BAMx Comments on the CAISO Transmission Access Forecasting Model

Introduction and Stakeholder Review

BAMx appreciates the opportunity to comment on the CAISO's 2018-2019 HV TAC Estimating Model ("TAC Model" hereafter) that was posted on the CAISO website on May 14, 2019, and which was subsequently discussed during the Stakeholder call on May 17, 2019. The comments and suggestions below address both the TAC Model and the May 17th stakeholder presentation. We hope that the CAISO addresses the issues raised by BAMx in the next update of its TAC Model.

Figure 1: A Comparison of the CAISO's HV TAC (\$/MWh) and Assumed Capital Expenditures (M\$)

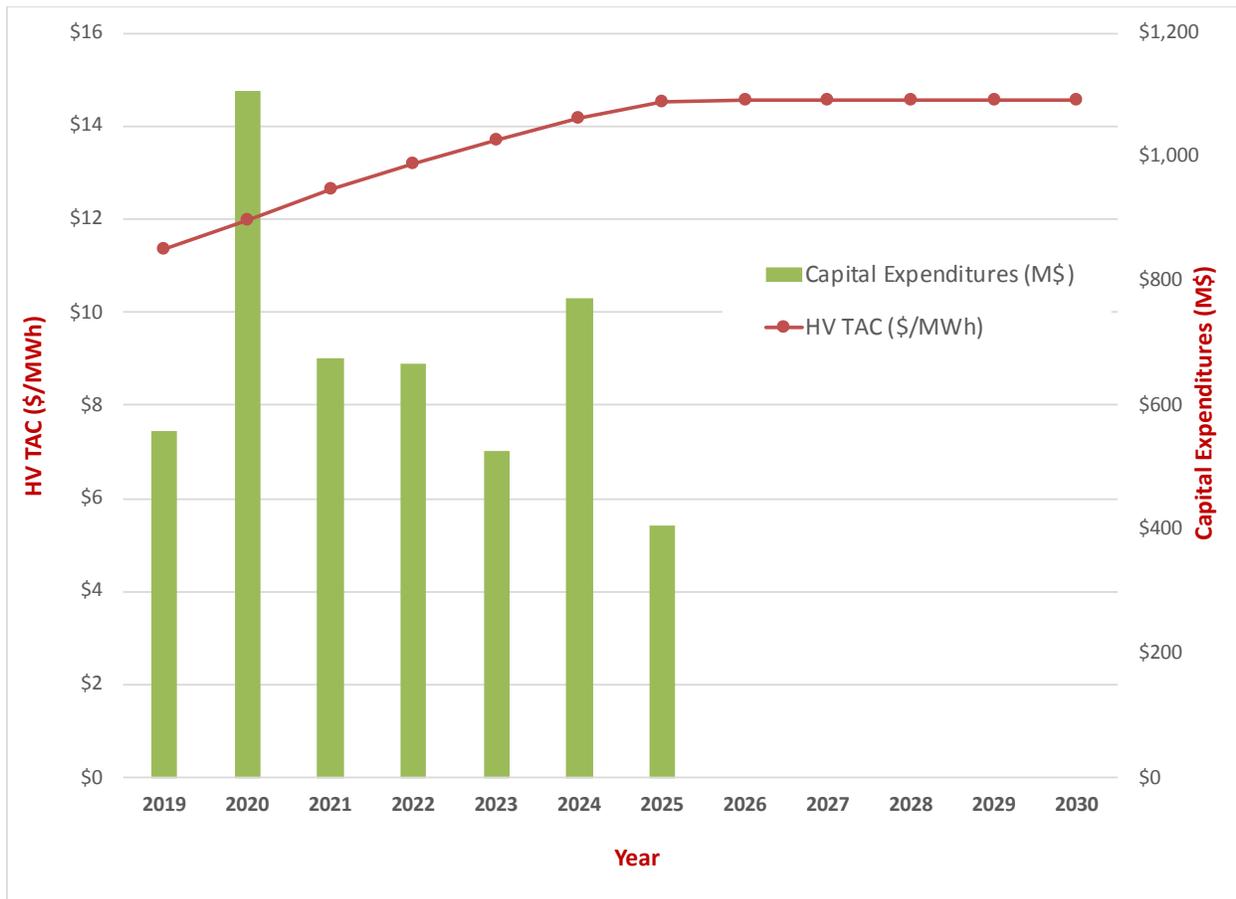
BAMx notes that the tapering of the CAISO's HV TAC forecast in the outer years, that is, during 2026-2030 is primarily driven by the very low levels of transmission capital expenditures assumed in the HV TAC forecasting model. As shown in Figure 1, the HV TAC forecasting

model assumes that the HV capital expenditures³ during the years 2023-2026, which is primarily driven by the CAISO-approved reliability driven transmission projects.

Clearly, one of the major reasons for a lower level of capital expenditures assumed in the outer years (2026-2030) in the TAC Forecasting Model is that they do not include the capital expenditures in the CAISO's upcoming TPP cycles. In other words, the HV TAC rates, especially for years 2026-2030 are likely going to be higher than those depicted in the current version of the HV TAC Forecasting Model. Furthermore, there needs to be a recognition that the HV TAC rates would be significantly greater upon the incorporation of the direct costs
